**Source:** TSG SA WG2  
**Title:** CRs on 23.920 v 3.1.0  
**Agenda Item:** 5.2.3

<b>TDoc #</b>	<b>CR #</b>	<b>spec</b>	<b>Title</b>
S2-99D20	010	23.920	Deletion of the Cell Broadcast System Architecture

**Subject:**    Deletion of the Cell Broadcast System Architecture

**Reason for change:**    As the CBS Architecture is moved to 23.121 this CR deletes the according section within the 23.920.

**Figure 5: Protocol Stack of the Common Communication Channel**

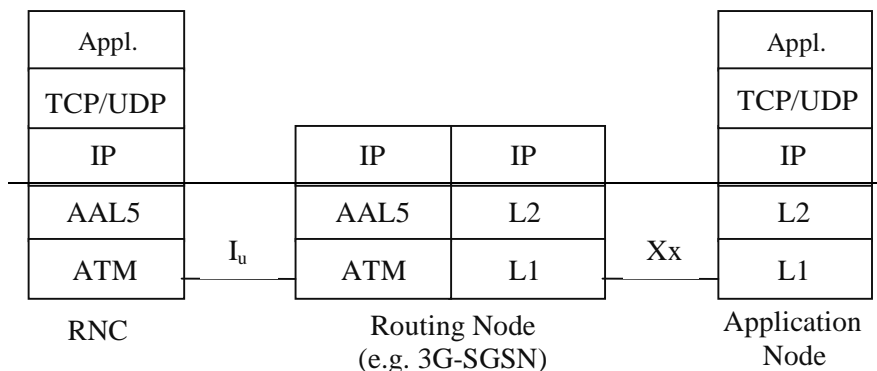
This communication mechanism would use e.g. an IP routing functionality of the 3G-SGSN. The according protocol stack is outlined in figure 5.

Figure 21: Architecture for SMS Cell Broadcast in UMTS

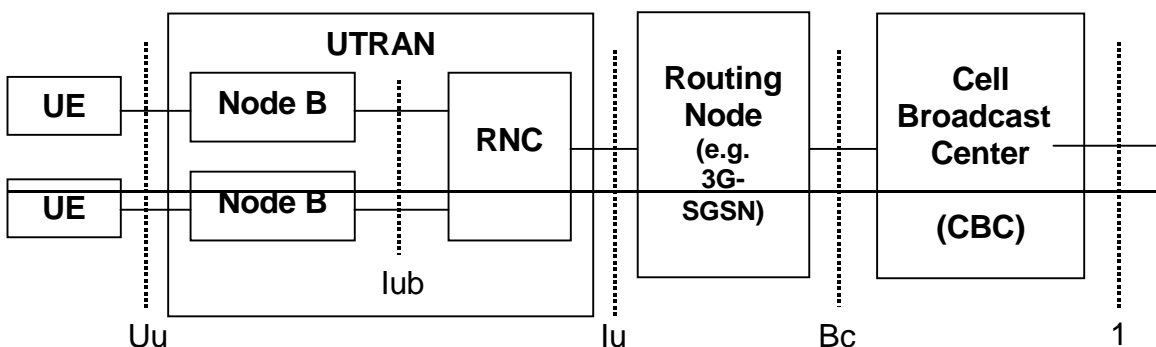
Figure 22 proposes a straight forward adoption of the GSM cell broadcast architecture in UMTS.

The basic network structure replaces the GSM BSS with the UTRAN containing the RNC and the Node B. The cell broadcast center (CBC) is part of the core network and connected to a routing node e.g. a 3G SGSN via the Bc reference point. Thus the CBC can reach every RNC via the user plane of the Iu interface by using the newly introduced common communication channel. On the logical interface between the CBC and the RNC a mandatory protocol shall be defined, which should mainly be adopted from the corresponding GSM specification (see GSM 03.41). The other UTRAN related interfaces are described in the according UTRAN specifications based on the RAN 2 TR 25.925. Based on this architecture and the current requirements for cell broadcast the core network elements like MSC, VLR, HLR etc are not involved for the service delivery.

~~Figure 22: Common Communication Channel used by the Cell Broadcast Application~~

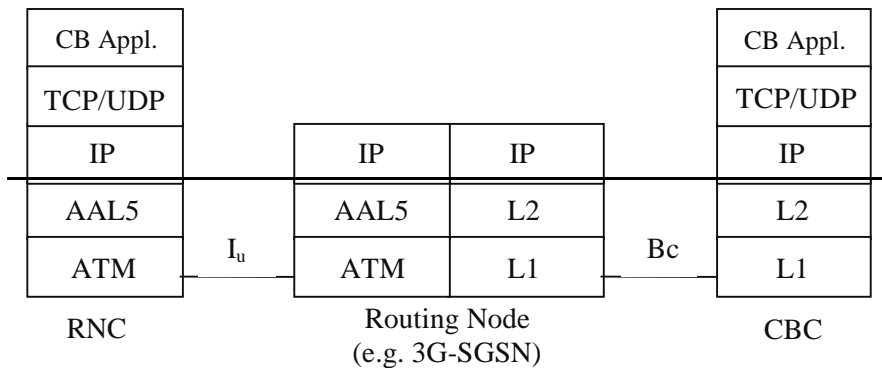
The protocol stack between the CBC and the RNC is given in figure 22. Protocol primitives for the cell broadcast application defined by GSM 03.41 are used for the Cell Broadcast application.
